# 17-7/8" to 20" ICDS Grapple Retention Retrofit Solution

### Issue

# Affected Equipment

All 17-7/8" to 20" ICDS tools regardless of the date of manufacture.

Figure 3

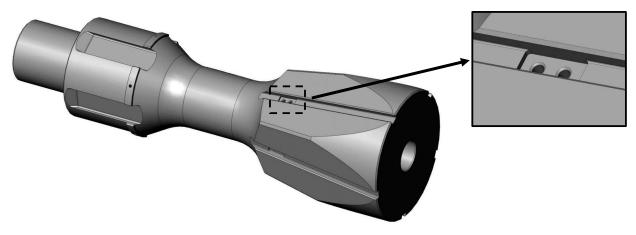
2. Modification of 'on-hand' Mandrel(s) – P/N: 860207 Rev. 0 – See Figure 3.

- Machine the slots, drill and thread the holes as per P/N: 5101740 Mandrel, 17-7/8" Modified for grapple retention.
- Refer to Appendix A for drawing 5101740.
- 3. Modification of 'on hand' Grapples (all grapple sizes 17-7/8" to 20") qty. 5 per set See Figure 4.

#### Grapple Retention Kit, 17-7/8" to 20" Grapples - Canrig P/N: 5101745

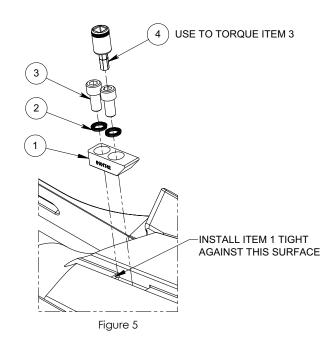
- 4. Grapple Retainers Procurement See Figure 5 on page 5.
  - a. Procure P/N: 5101745 Kit, Grapple retention, 17-7/8" to 20" grapples from RIGLINE 24/7™. The kit includes the following parts:

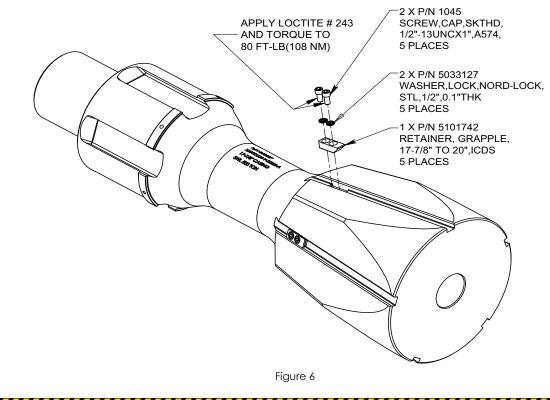
- 5. Assemble P/N: 5101742 Grapple Retainers (qty. 5) on the modified mandrel.
  - Refer to Figure 6 for the assembling detail.

- Apply Loctite #243 to the screws.
- Ensure the correct orientation of the Grapple Retainer.
- Ensure the proper installation of the Nord-Lock washers.
- Ensure the retainer is tight to the face of the pocket before the cap screws are tightened. See Figure 7:

- Use P/N: 50101750 Allen Bit Socket and appropriate Torque Wrench to tighten the screws to 80 ft-lb.
- 6. Re-assemble the Drive with modified mandrel to the actuator.
  - Refer to the CDS Maintenance Guide Document # 883004 for instructions on how to re-install the mandrel and other Drive components to the Actuator.
- 7. Install modified Grapples.
  - Refer to the CDS Installation and Operations Guide Document # 883003 for instructions on how to install the grapples.

Appendix B – P/N: 5101741 – Grapple, 17-7/8" – 20", Modified for retention

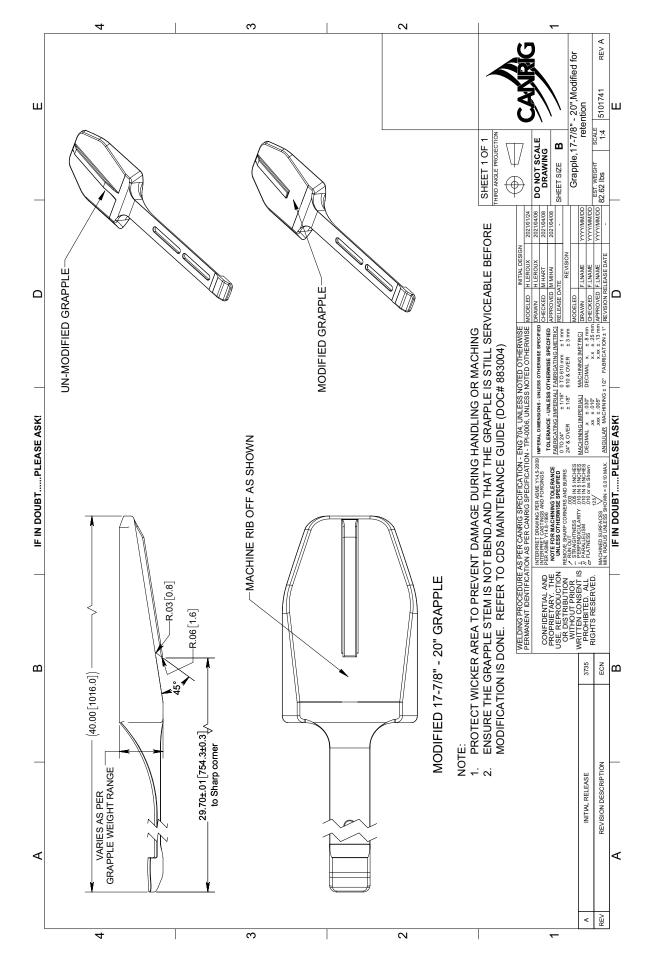
- If it is determined that the grapples are still serviceable, modify the grapples' rib as per P/N: 5101741 Grapple, 17-7/8" 20", Modified for retention.
- Refer to Appendix B for drawing 5101741.

#### Appendix C – P/N: 5102155 – Kit, CDS control function lock

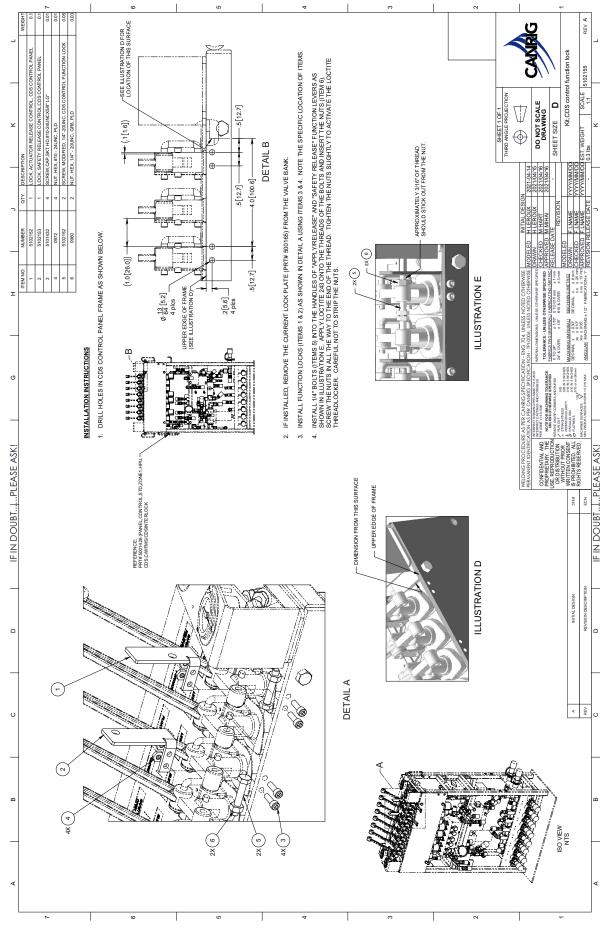
- 8. Install P/N 5102155 (Kit, CDS control function lock) on the CDS control panel to provide a means to constantly apply release hydraulic pressure.
  - Procure P/N 5102155 Kit from RIGLINE 24/7™.
  - Follow the installation instructions on the drawing no. 5102155 (See Appendix C) to install the kit.
  - To apply constant release pressure to the CDS actuator, move the Apply/Release and Safety release function levers to RELEASE mode and slide the pins into the holes in the function locks. This will prevent the levers from moving back to the neutral position.
